PROPERTY CONCERNED: Facility Name J.W. Green Residence

Address 6421 Lake Road City Zip 28227

SERVICE REQUESTED: PLEASE ADVISE WHETHER OR NOT THE WASTE WATER DISPOSAL SYSTEM OR REPAIR SPACE WILL BE AFFECTED ADVERSELY BY ADDITION OF A SWIMMING POOL AS PROPOSED IN ATTACHED PLAN

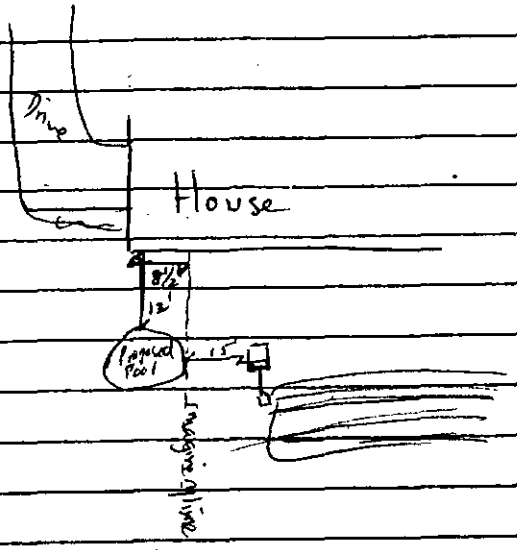
DATE	ACTIVITY REPORT
	Cartridge filter to be installed / Lathan
	File 831A
7-7	Site visit for pool location moved to be 15' from septic tank system (It was ± 5' from system before). Approved for new site location.
	Above ground pool.
